FOUNDATION REPORT

WYNOOCHEE DAM

US Army Corps
of Engineers
Seattle District

CENPD-EN-G (CENPS-EG-G/8Jul88)(1130-2-320b) 3rd End Munger (503)326-3867
SUBJECT: Wynoochee Dam Foundation Report, 1988

U. S. ARMY ENGINEER DISTRICT, SEATTLE				
CORPS OF ENGINEERS				
SEATTLE, WASHINGTON				
FOUNDATION REPORT				
FOUNDATION EXCAVATION—MONOLITH 7				
WYNOOCHEE DAM				
WYNOOCHEE RIVER			WASHINGTON	
DESIGN	INVESTIGATION NO.	FILE NO.	DATE	SCALE
D		E-67-6-4	DEC 67	12
DRAWN ECKERLIN		CHKD GALSTER		APPD

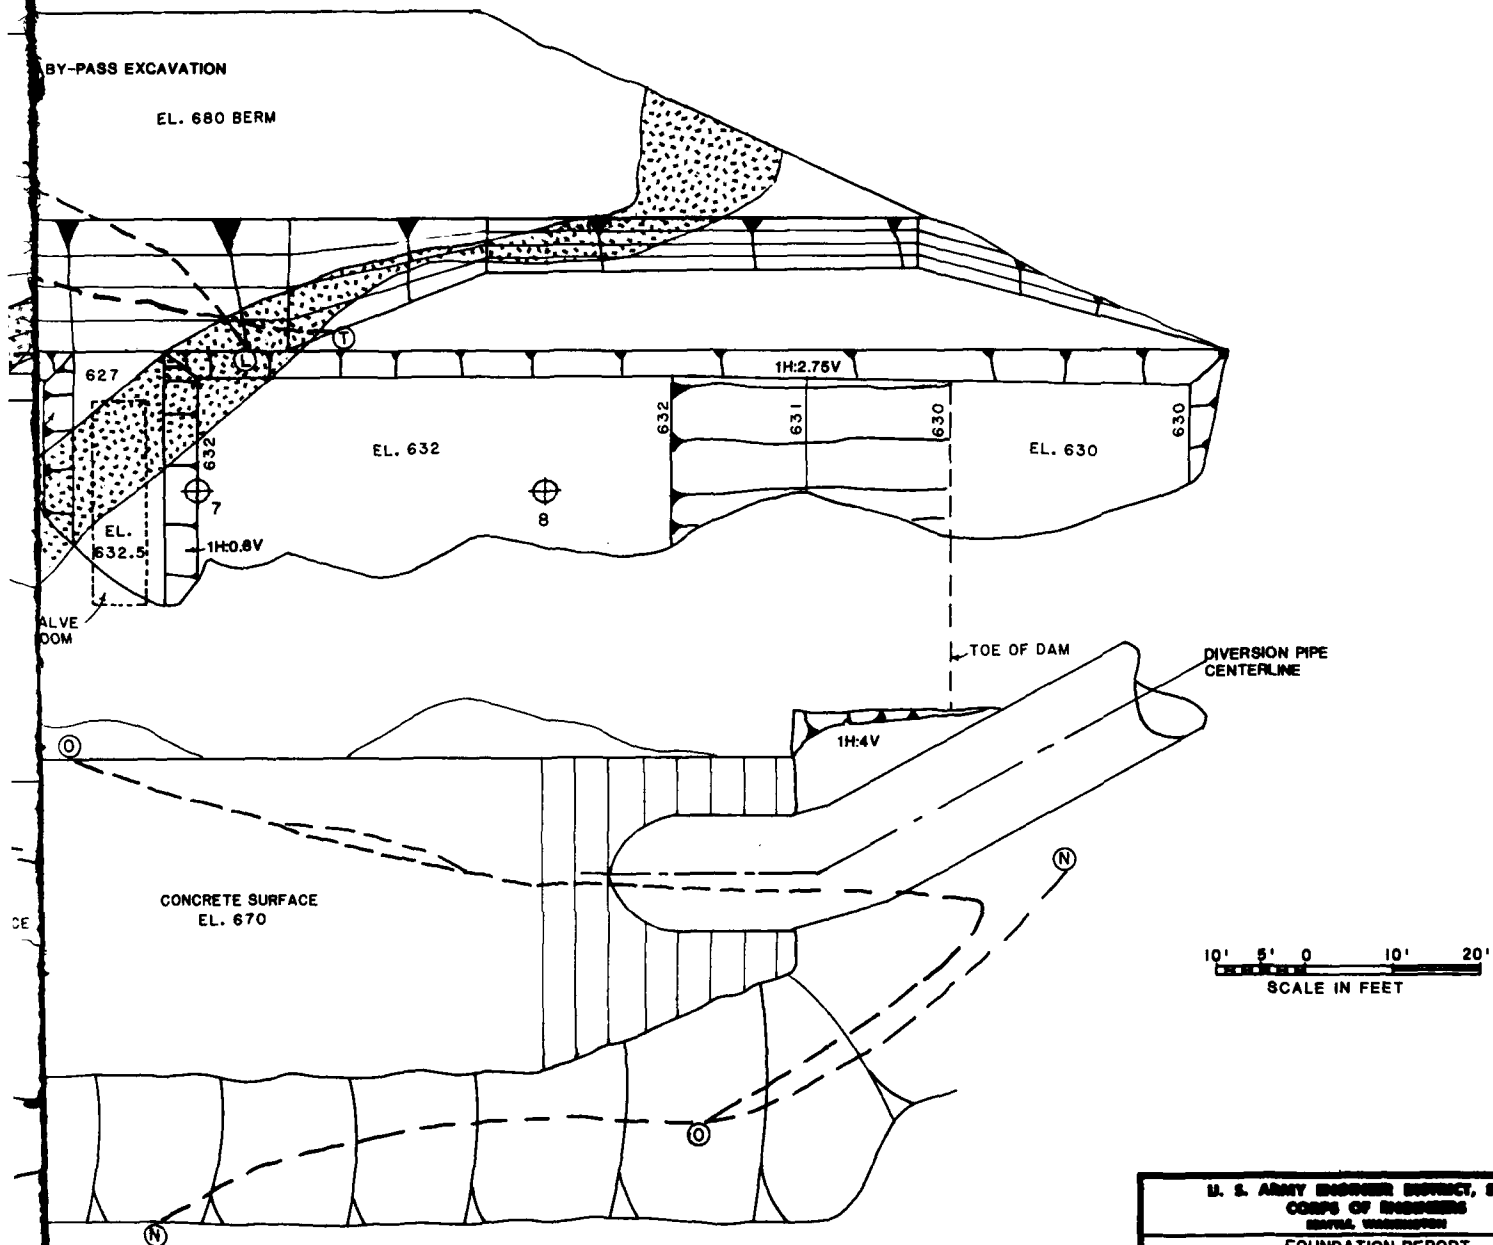
e. There are no plates that show excavation drawings for the structure, other than monoliths 6 and 7 (Plates 11 and 12). If this information is available, it should also be added to the report.

- a. Concur
- b. A shear strength of 500 psi was used in analysis. The 2,500 psi shown was a typographical error. The word "conservative" pertains to the shear strength for the foundation rock not the concrete/rock interface. The shear strength at the interface was also assumed to be 500 psi, however, no rationale for selection of this value is available.
- c. Concur
- d. There are no plates available that show "as mapped" geologic sections. Plate 14 in Appendix B presents geologic and embankment sections that have been compiled using data interpreted from other drawings in this appendix.
- e. There are no available plates that show as-built excavation drawings for the structure other than what is already included in the foundation report.
